**CITY OF MOUNTAIN VIEW  
MEMORANDUM**

SUBJECT: MAY 25, 2010 STUDY SESSION—HIGH-SPEED RAIL ALTERNATIVES ANALYSIS

The purpose of this Study Session is to gain Council input on proposed comments from the City to the California High-Speed Rail Authority (CHSRA) on the Preliminary Alternatives Analysis Report (AA) for the High-Speed Rail (HSR) project.

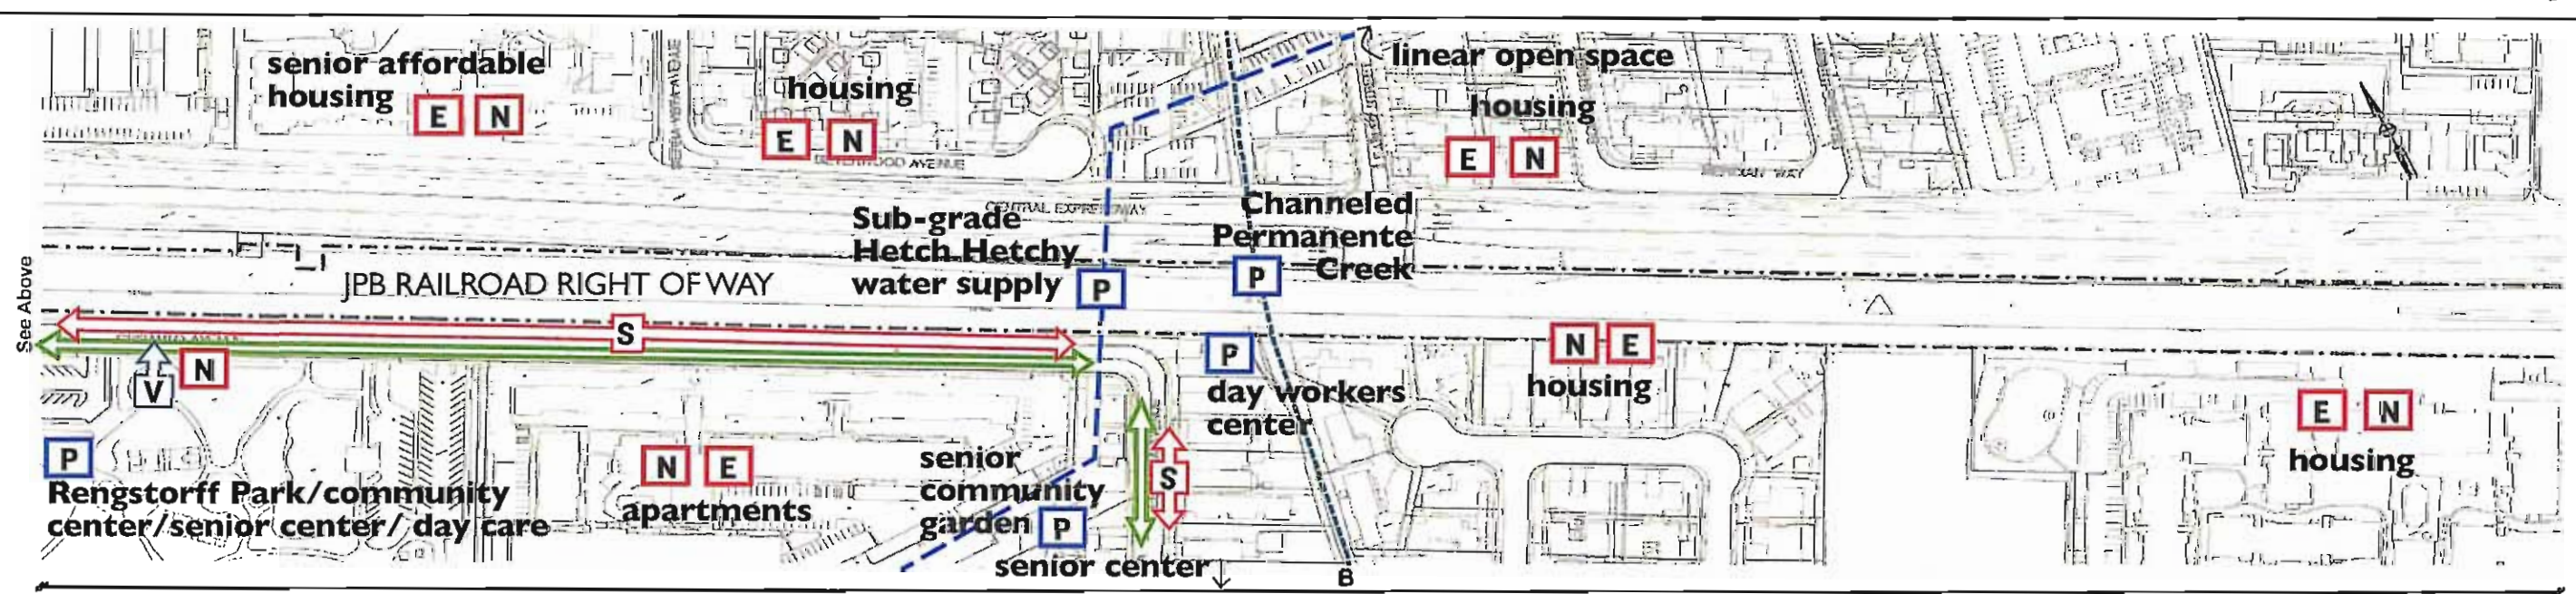
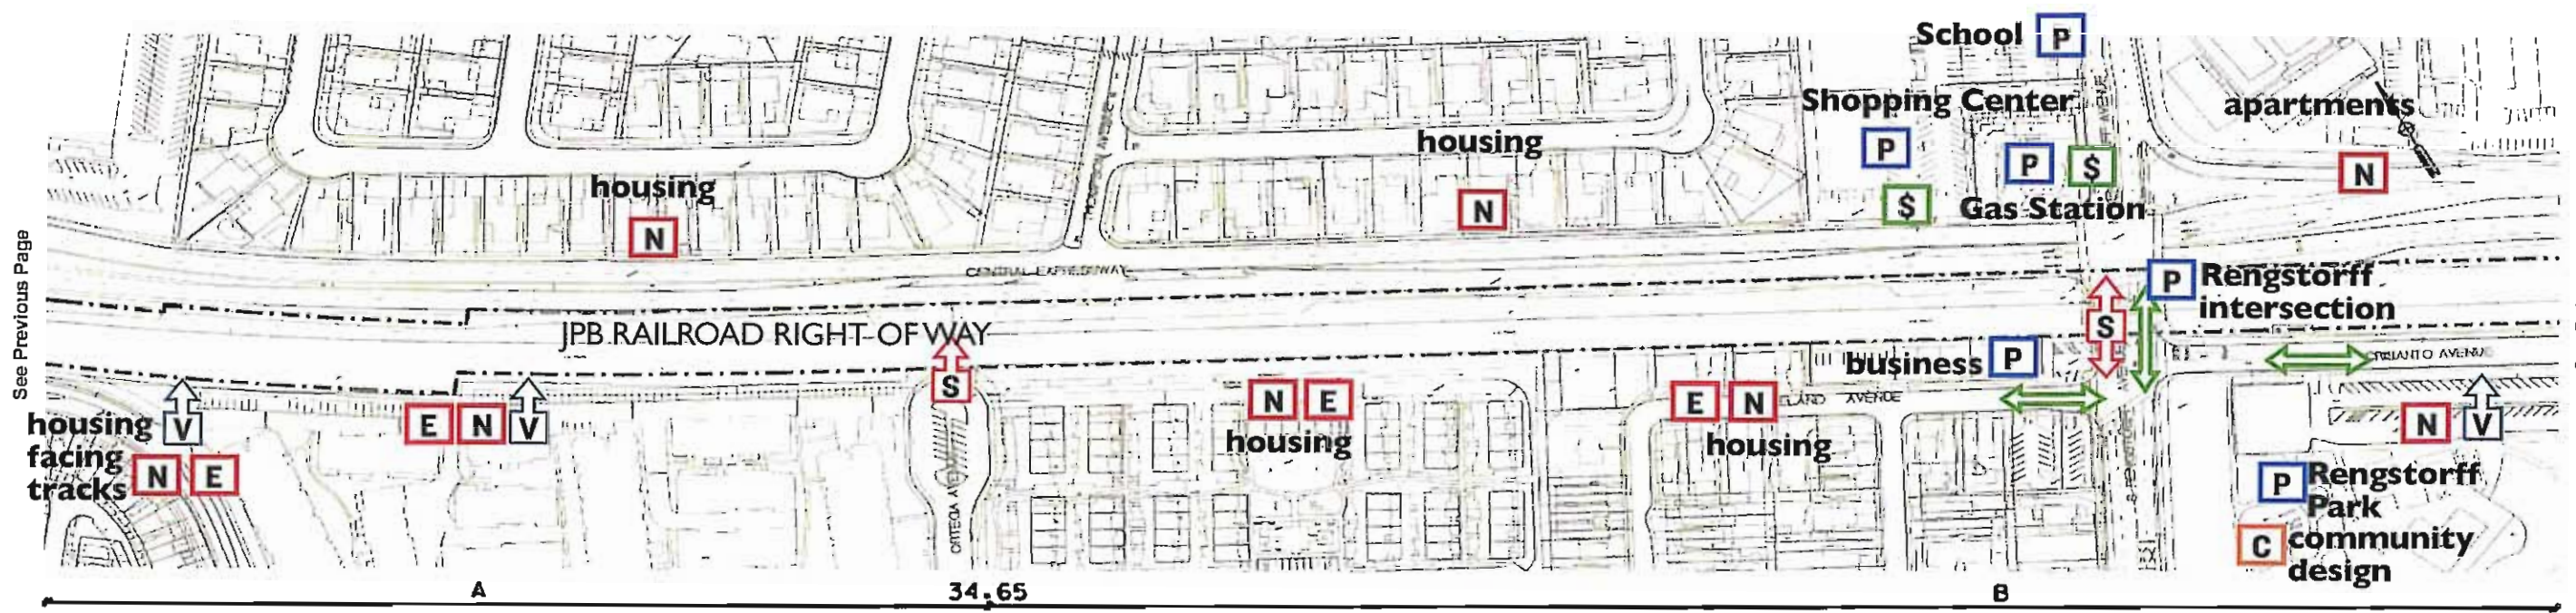
E: Minority businesses. Minimize impact.  
S at Rengstorff: Improve safety for crossings as crossing is used by nearby schools and businesses.  
Maintain cross connectivity at Rengstorff.  
Provide east side access to the San Antonio platform.

- Provide descriptions of items drawn and identified in the above maps.
- Safety and connectivity to Rengstorff Park, senior center, senior gardens and day workers' center.
  - Conflicts with Permanente Creek culvert and PUC Hetch Hetchy waterpipes.
  - Improve safety and connectivity at rail/Rengstorff/Central Expressway intersection.

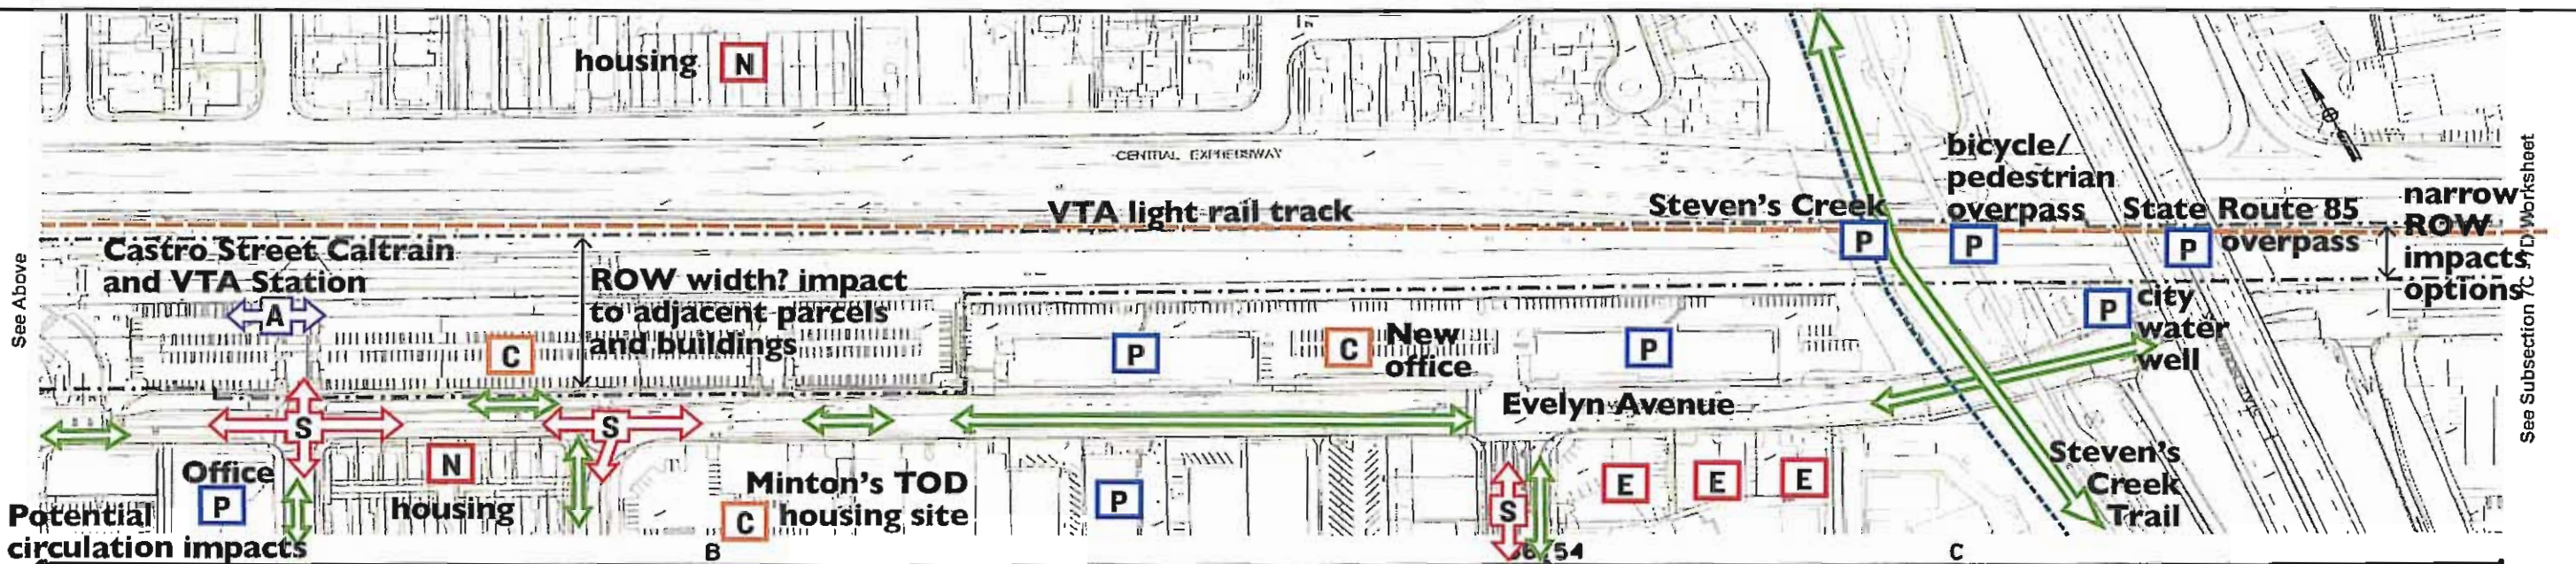
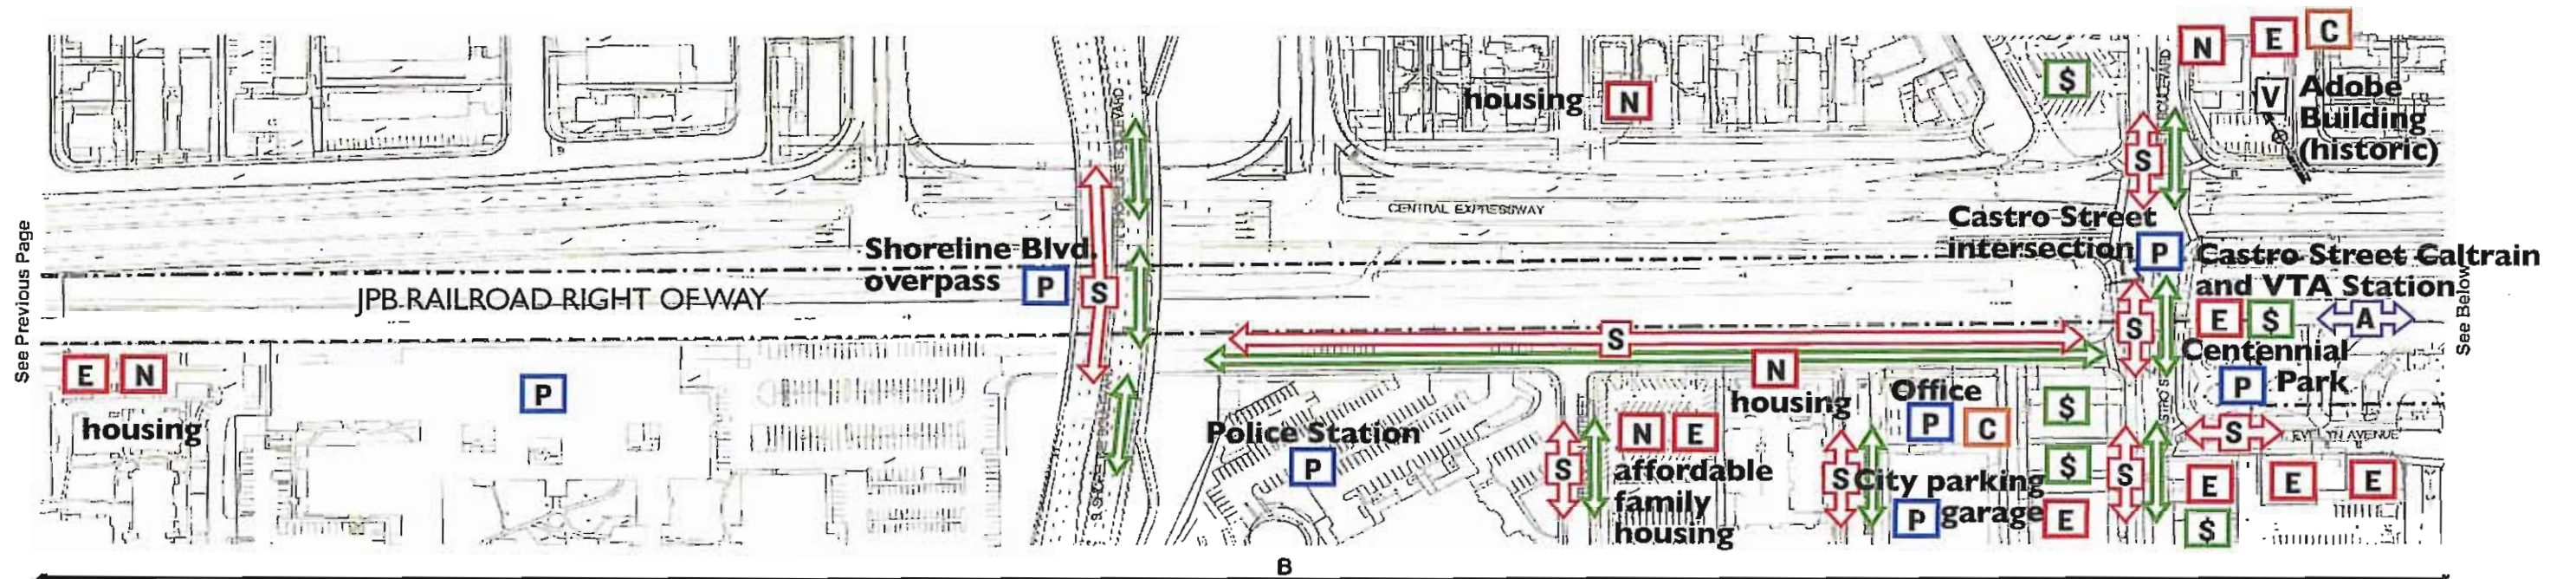
- Better access to and from Caltrain/Light Rail. Historic downtown/Castro Street- visual character, safety, local businesses, maintain accessibility and connectivity.
- Community has a Downtown Precise Plan and an Evelyn Ave. Corridor Precise Plan for this area .
- Major physical impacts to streets, roads and adjacent properties. Major visual impacts, especially from Castro Street. Major connectivity impacts - station area as well as city circulation.
- Major economic vitality impacts, potentially to adjacent properties.
- Maintain the amount of existing parking at Castro Station, opportunity for parking structure.

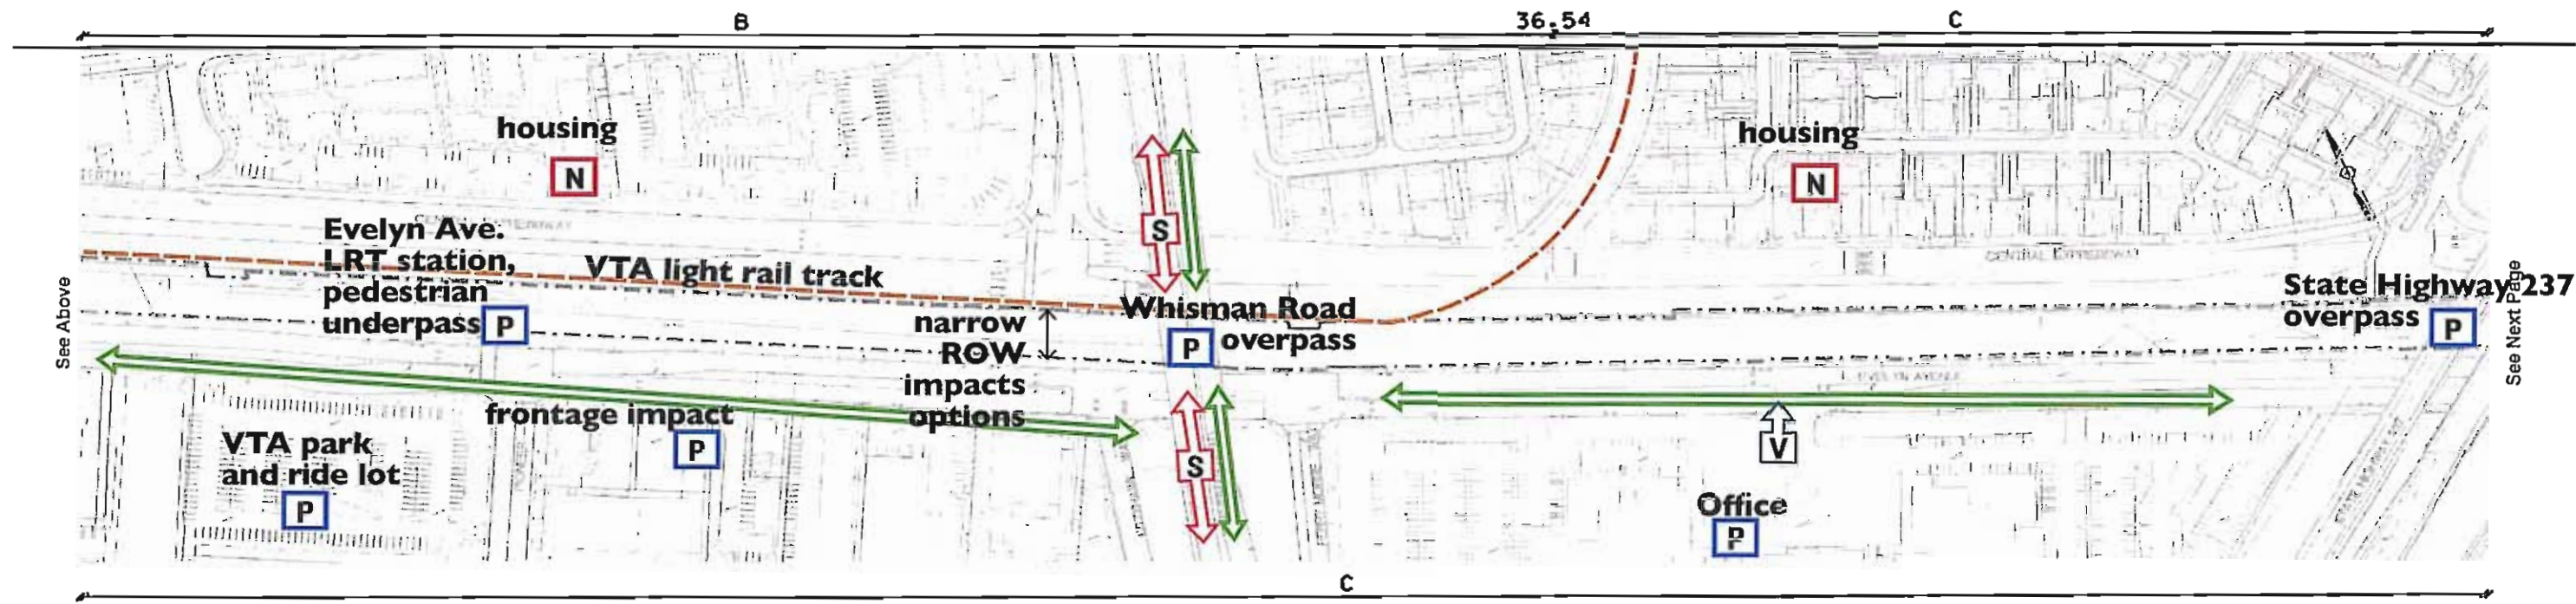
- Maintain safety and connectivity on Whisman, required.
- How will VTA light rail station/pedestrian underpass integrate with HSR at grade?
- Bernardo - not currently connected over Central Expressway - possible improvement (bike/pedestrian or vehicle).
